**PREVOST**

**MAINTENANCE  
INFORMATION**

**MI13-46**

DATE :	JUNE 2013	SECTION: 06-Electrical
SUBJECT :	DIODE ADDITION TO 24CO CIRCUIT

Partial wiring diagram shown as reference (complete wiring diagram of the circuit can be found under # D061140p5.1r7 on the [Prevost Technical Publication](#) web site).

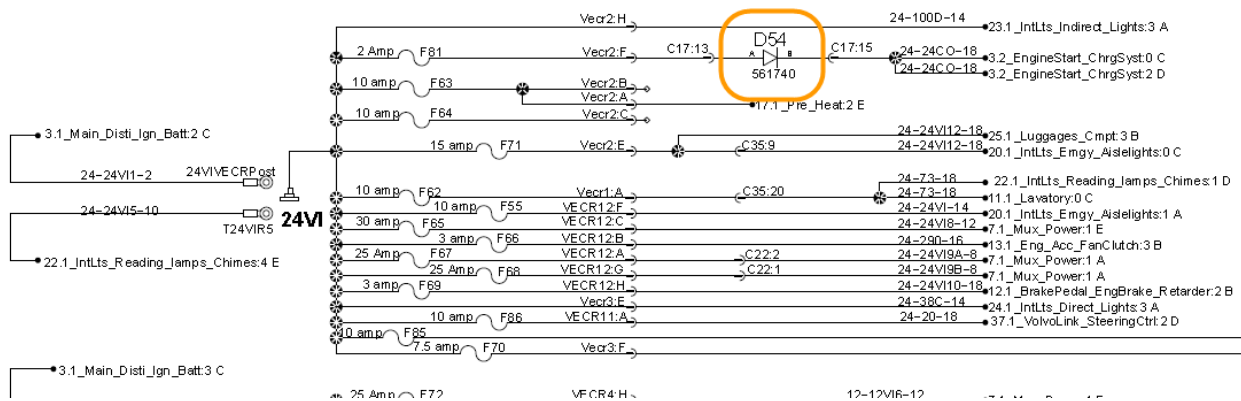
On some post EPA 2010 vehicles, it is possible for the combined charging and starting system F81 fuse to blow unexpectedly.

To avoid this situation, a 3 amp diode can be added to the corresponding 24CO circuit to prevent electrical back-flow to the fuse.

Fig.10 3amp diode installation.

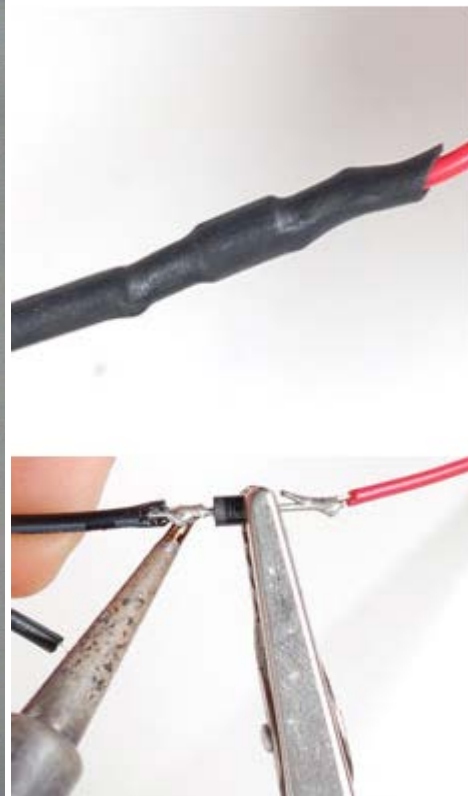
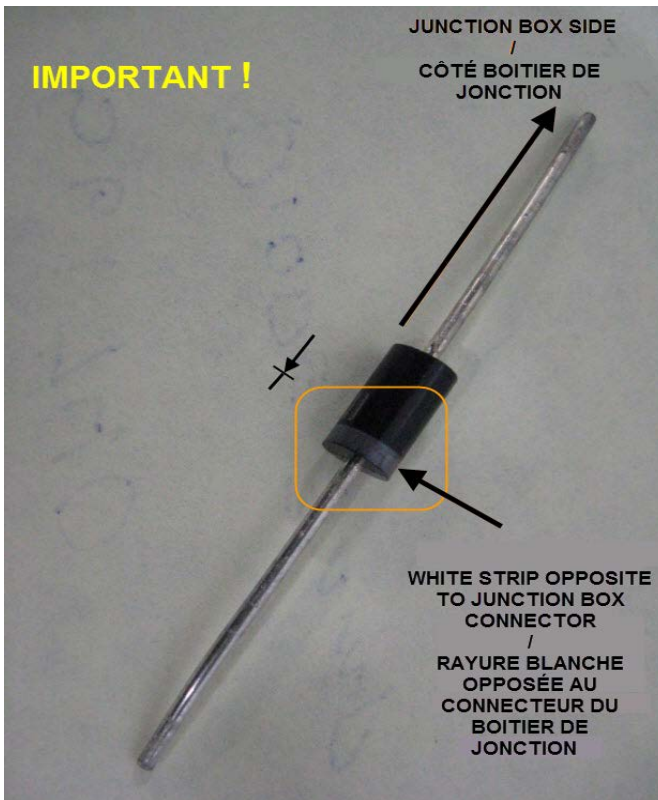
- Insert a 10cm (4inches) length of shrink tubing (#562499 or equivalent) over the harness end of the 24CO wire.
- Solder a 3amp diode between the ends of the stripped wire.

**NOTE: The diode must be soldered with the white strip opposite to the Junction box connector.**

7. Slip the heat shrink tubing over the diode and apply heat to insulate the wire/diode assembly.
